METROPOLITAN AREA PLANNING
COMMISSION

Re: S/D 84-3 - Final plat of Timber Grove Lakes

Re: S/D 84-3 - Preliminary plat of Timber Grove Lakes

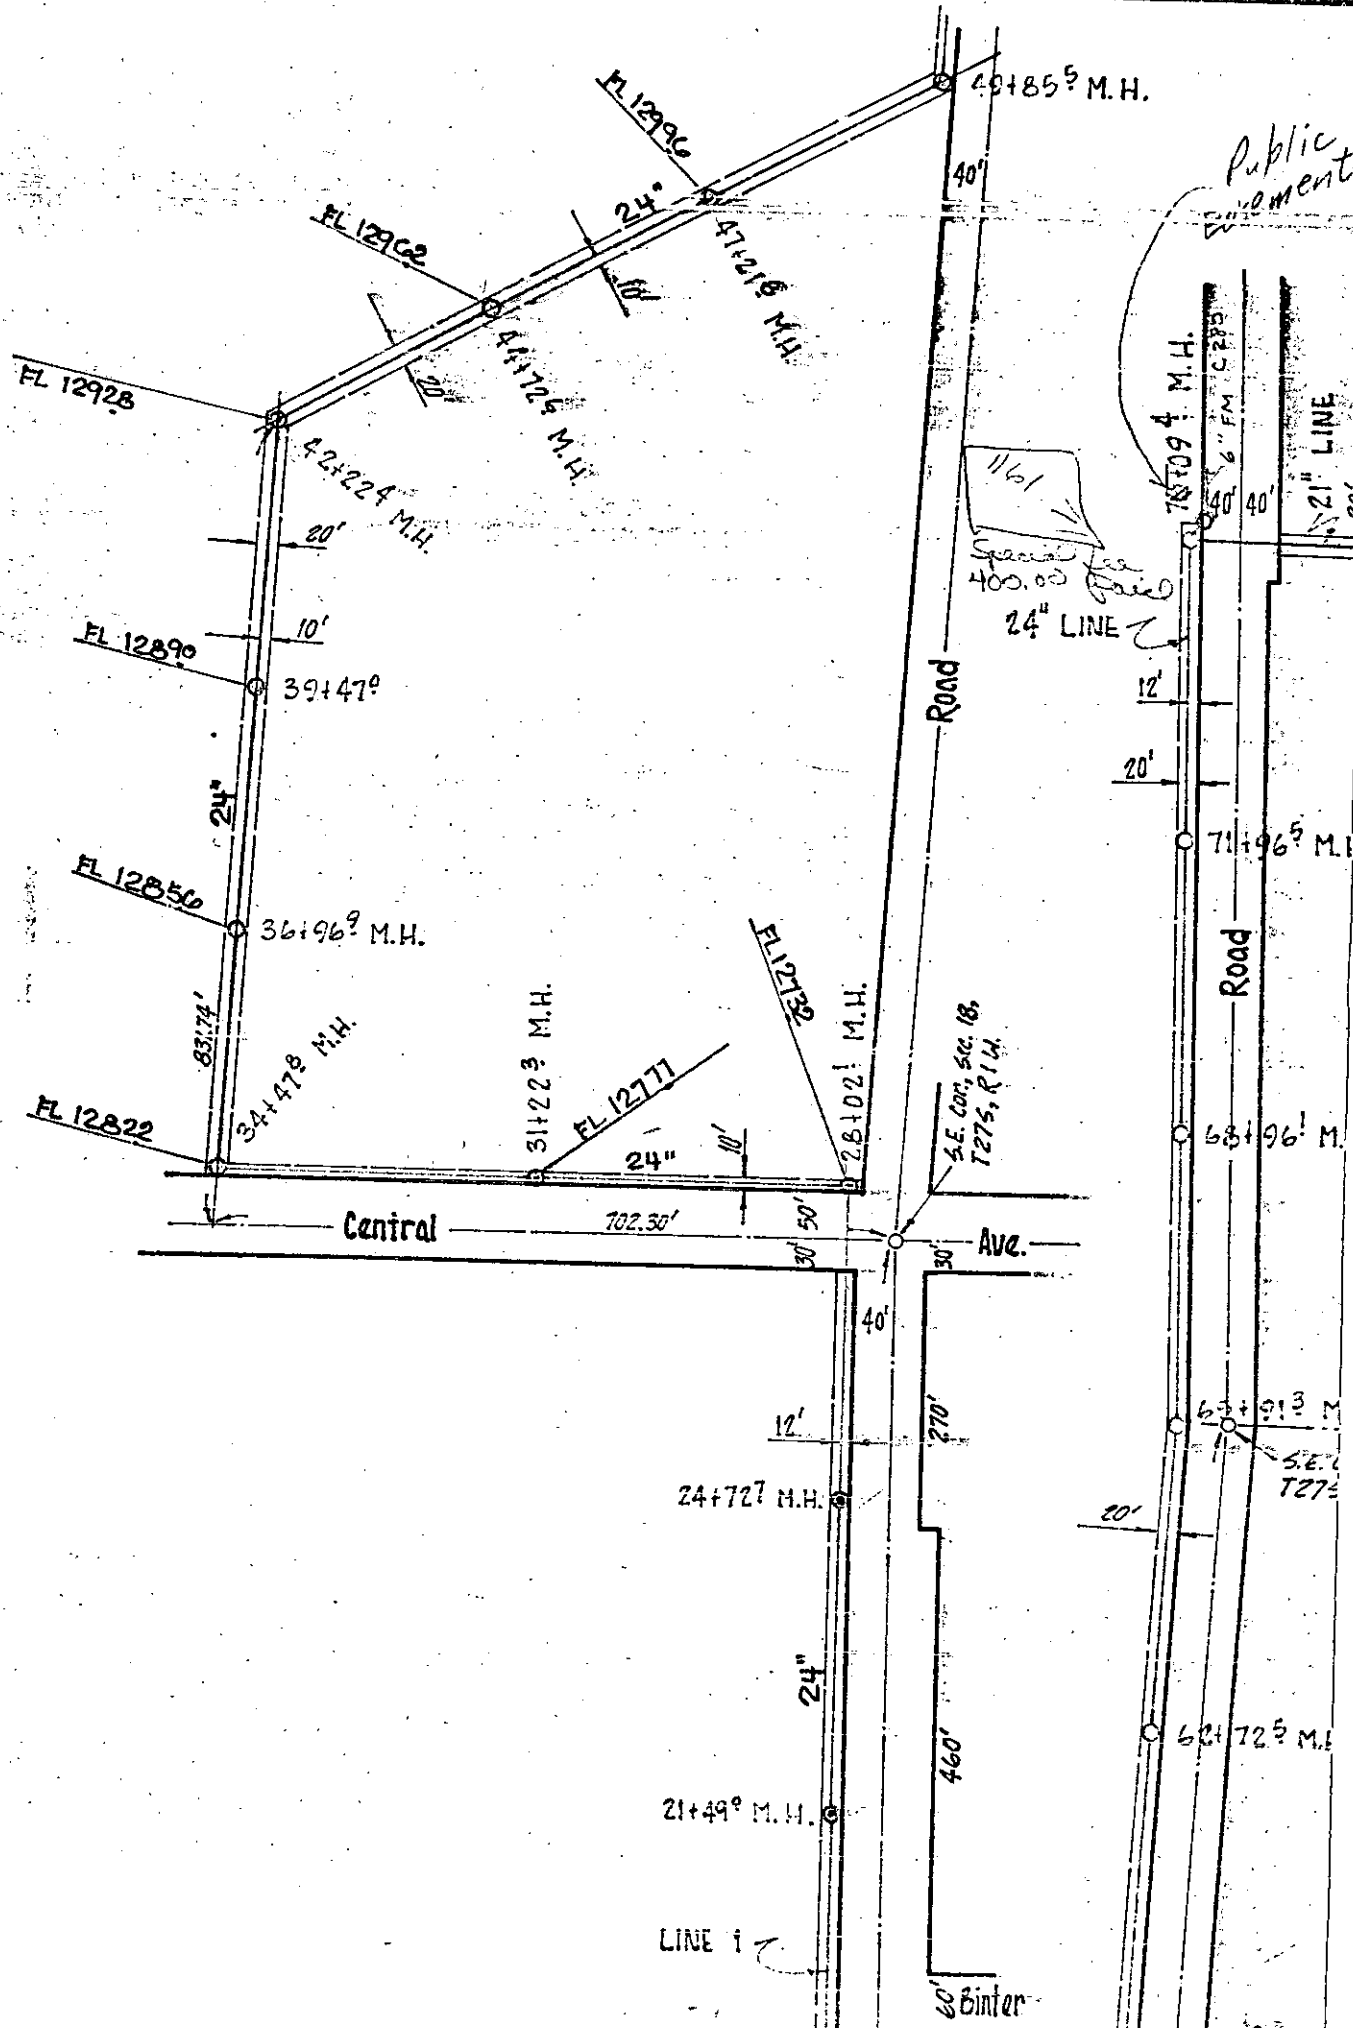
The on-site drainage improvements do not need to be guaranteed at this time.

The channel and lake have been constructed. The sanitary sewer will be guaranteed by petition.
